Subject: Revision to Unit 3 Cycle 17 Core Operating Limits Report

# **Core Operating Limits Report**

**Dresden Station**

**Cycle 17**

**FIGURE 5.2-2**

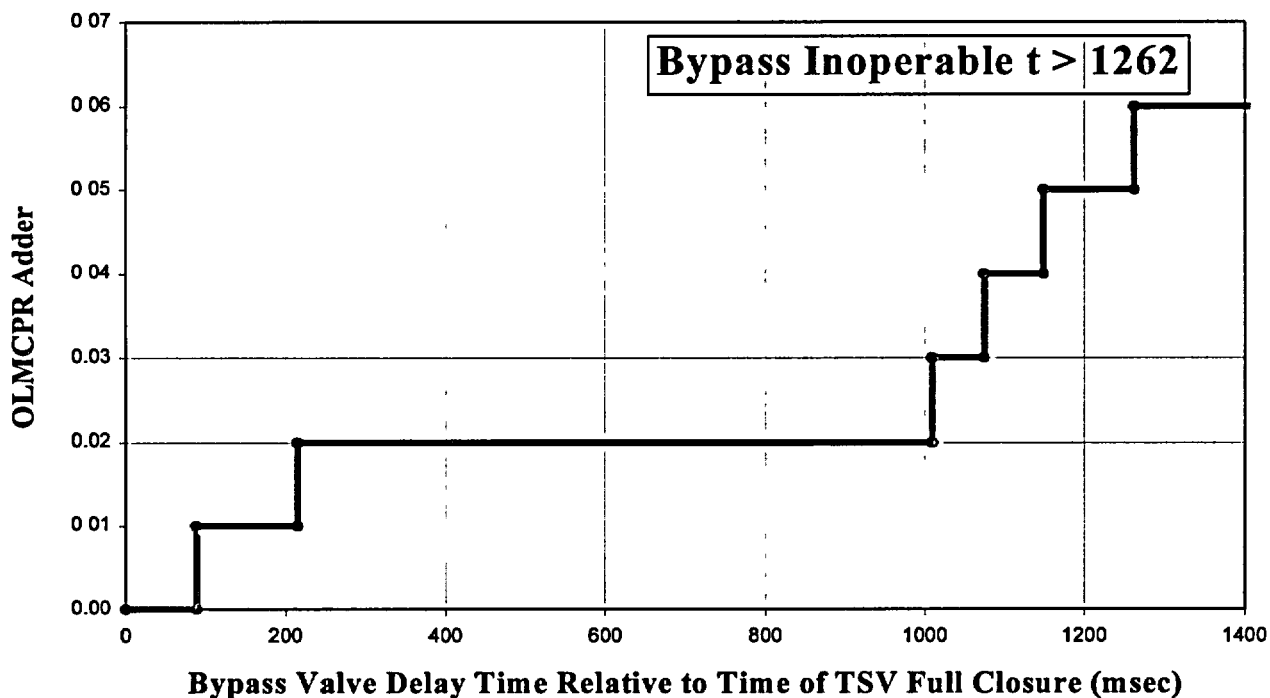
Affected Section	Affected Pages	Summary of Changes	Date
All	All	Original Issue Cycle 17	10/00
5.2	5-1, 5-2, 5-3	Section 5.2 was revised to be consistent with the format used in the D2 C17 COLR.	3/01
6.0	6-1, 6-2	Added references CTS 6.9.A.6.b.1-6.9.A.6.b.13 (ITS 5.6.5.b.1-5.6.5.b.13), including the reference revision number and date	
1.0	1-2	Added Allowable Value to the title heading of table 1.2-1 to be consistent with ITS.	
5	iii, 5-2, 5-4	Revised OLMCPR to reflect analysis results in response to Part 21 with notification event # 37874	7/01
All	ii, 1-1, 1-2, 2-1, 2-3, 3-1, 4-1, 5-1, 5-3, 6-1	Removal of historical Current Technical Specification References, identification of new Technical Specification references, and re-titling to reflect the new Technical Specifications	
5	iii, 5-2, 5-4	Insert reference to allow 120°F Final Feedwater Temperature Reduction, updated Figure 5.2-2.	8/02

<b>Bypass Valve (BPV) Delay Time (msec)</b>	<b>OLMCPR Adder<sup>1,2</sup> (ΔCPR) ATRIUM-9B (offset and non-offset) &amp; 9x9-2</b>
0 ≤ t ≤ 50	0.00
50 < t ≤ 89	0.00
89 < t ≤ 215	0.01
215 < t ≤ 1010	0.02
1010 < t ≤ 1075	0.03
1075 < t ≤ 1149	0.04
1149 < t ≤ 1262	0.05
t > 1262	0.06
Two or more BPV inoperable <sup>2</sup>	0.06
